HISTORIC AND DESIGN REVIEW COMMISSION

Agenda Item No: 27

HDRC CASE NO: 2016-238
ADDRESS: 315 W LYNWOOD
LEGAL DESCRIPTION: NCB 6386 BLK 6 LOT 13 THRU 22
ZONING: R5 H
CITY COUNCIL DIST.: 1
DISTRICT: Monte Vista Historic District
APPLICANT: Lauren Dillberto
OWNER: Dennis Karbach, Robert Brown
TYPE OF WORK: Final approval for installing windows, new construction of a garage, driveway modifications, landscaping

1 ELEVATION WEST @ LOGGIA
SCALE: 1/4"=1'-0"

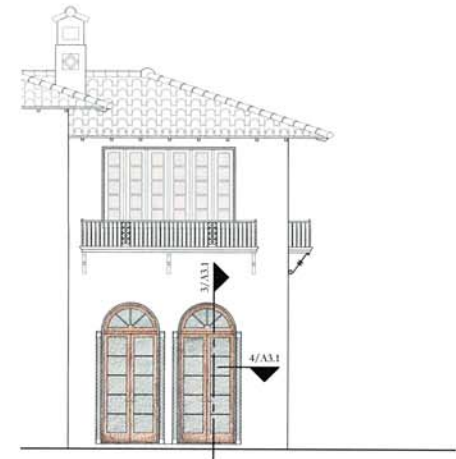
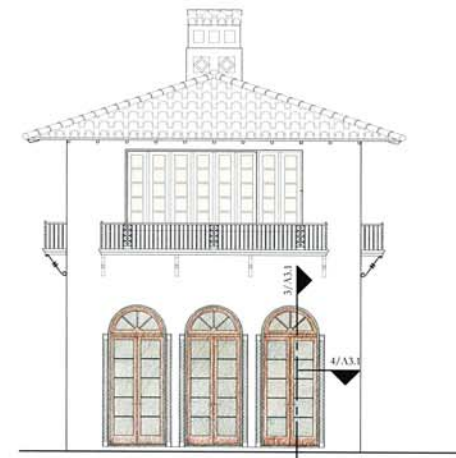
- k. REQUEST #8 - The applicant is proposing to enclose and install seven new narrow stile doors at East loggia. Currently, the loggia has seven arched openings facing a patio and the east lawn. The applicant provided current photographs of other homes in the district that have enclosed loggias. The doors to be installed will be narrow stile doors, each with 12 paneled lights and 4 fan lights, set back 10" beyond the exterior wall. According to the Guidelines for Exterior Maintenance and Alterations 6 states to avoid altering openings and use doors or windows that reflect the architectural style of the building. Staff finds the placement and style of the doors appropriate as they will not alter the window opening and the doors are appropriate for the Spanish Eclectic style.

Staff recommends final approval of items # 1 through #9 based on findings a through l with the following stipulations:

1 SOUTH ELEVATION @ GARAGE

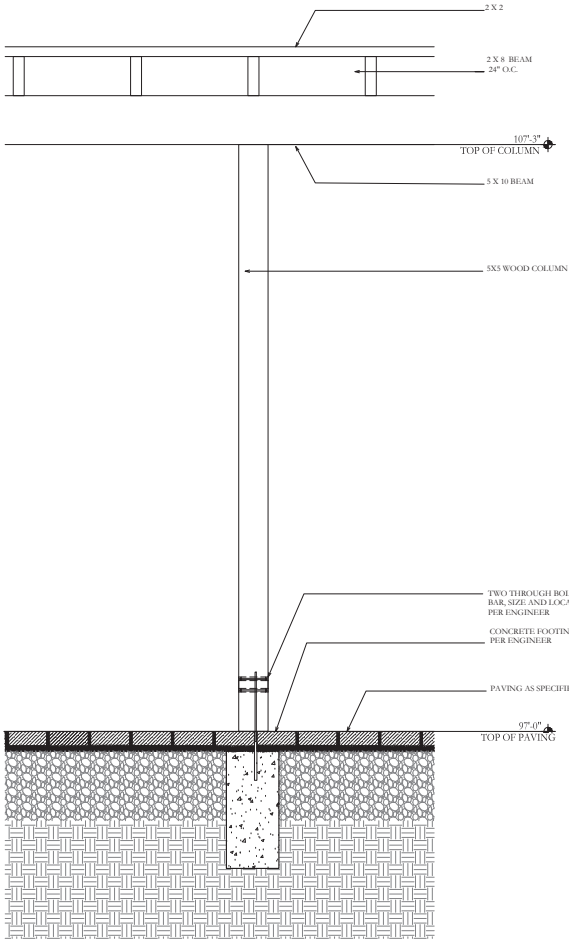
STAFF NOTE: MIDDLE WINDOW DOES NOT MATCH EXISTING

PROPOSED:
EAST/FRONT ELEVATION OF EXISTING GARAGE

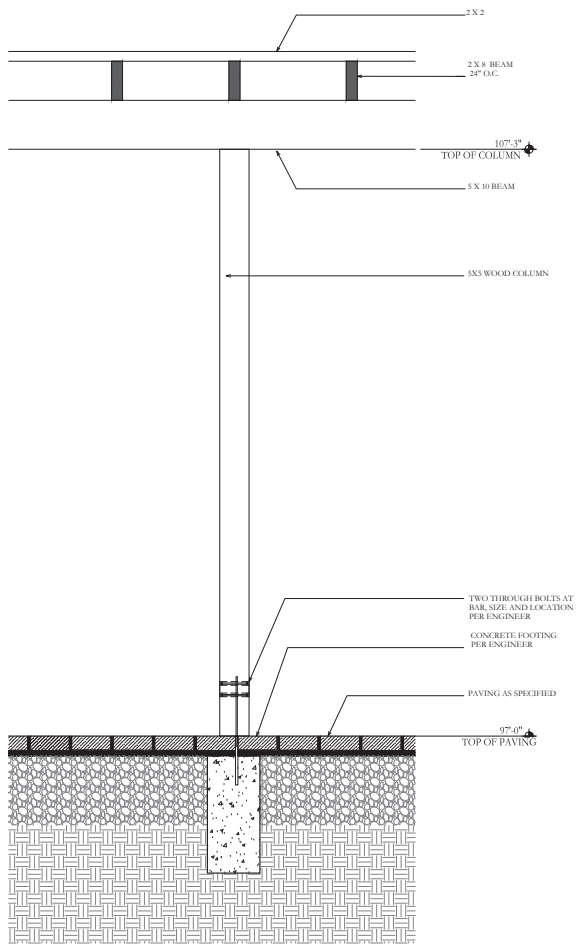
- m. REQUEST #10 - There is an existing garage that is Spanish eclectic style, two-stories with a flat roof and flared corners. On the existing front façade there are 3 car bays, two 6 over 6 windows and one 3 over 3 window. The applicant is proposing to remove the existing garage doors and install 3 loggia style openings and install doors to match those enclosing the loggia. The applicant is not proposing to alter the rear or side façades. According to the Guidelines for Exterior Maintenance and Alterations 6.B.i, window openings should be preserved. Staff did not find the existing garage on the August 1935 Sanborn map. The Carriage House is identified in the 1998 as contributing. Staff finds the existing garage contributing, and recommends that minimal alterations be made and that all openings be retained. Staff finds the proposal to alter the garage bays and the 3 over 3 window opening not consistent with the Guidelines.

Staff recommends denial of item #10 based on finding m. Staff recommends that openings be preserved.
